UNITED STATES PATENT AND TRADEMARK OFFICE

Office Action Summary	Application No. 10/810,231	Applicant(s) TOOMEY ET AL.
	Examiner Ginger T. Chapman	Art Unit 3761

DETAILED ACTION

Fig-9

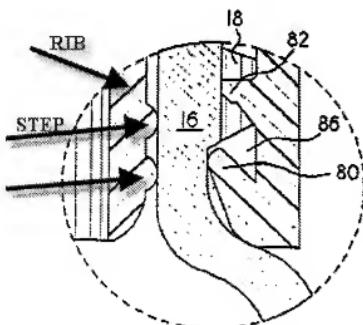
10. With respect to claims 6 and 7, Manera discloses the base 22 defines a plurality of ribs, the ribs defining a step for supporting the housing. The ribs and steps are not labeled with a reference number and therefore Figures 2A (22), 8 and 9 respectively are reproduced below with arrows indicating the ribs and steps for clarity:
